**2016-7293: 1008 E El Camino Real and  
1314-1320 Poplar Ave.  
Rezone, Special Development Permit &  
Vesting Tentative Parcel Map**

# PROPOSED REAR ELEVATION

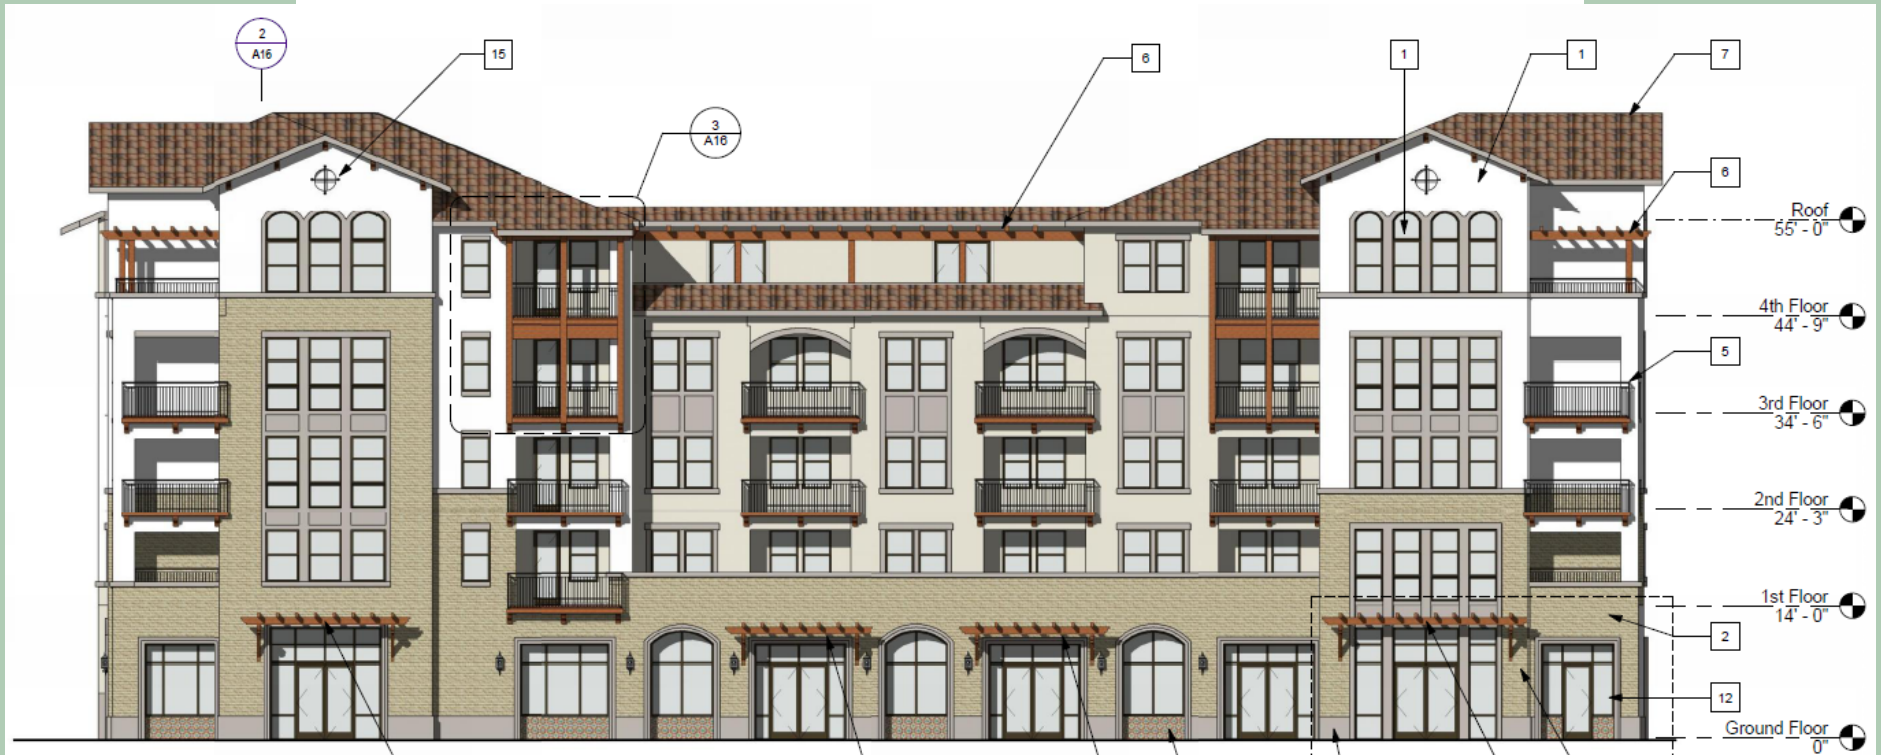
- Soften the front elevation and enhance side elevations
- Incorporate native large species trees along ECR frontage
- Prioritize long-term success over immediate effect in landscaping plan
- Add a park strip
- Improve pedestrian realm w/ lighting & seating
- Incorporate artwork into project frontage
- Set back five bays on ground floor
- Incorporate hip roofs instead of gables into front towers
- Require 22 affordable units remain affordable at condo conversion
- Ensure primary use of ECR driveway vs. Poplar driveway
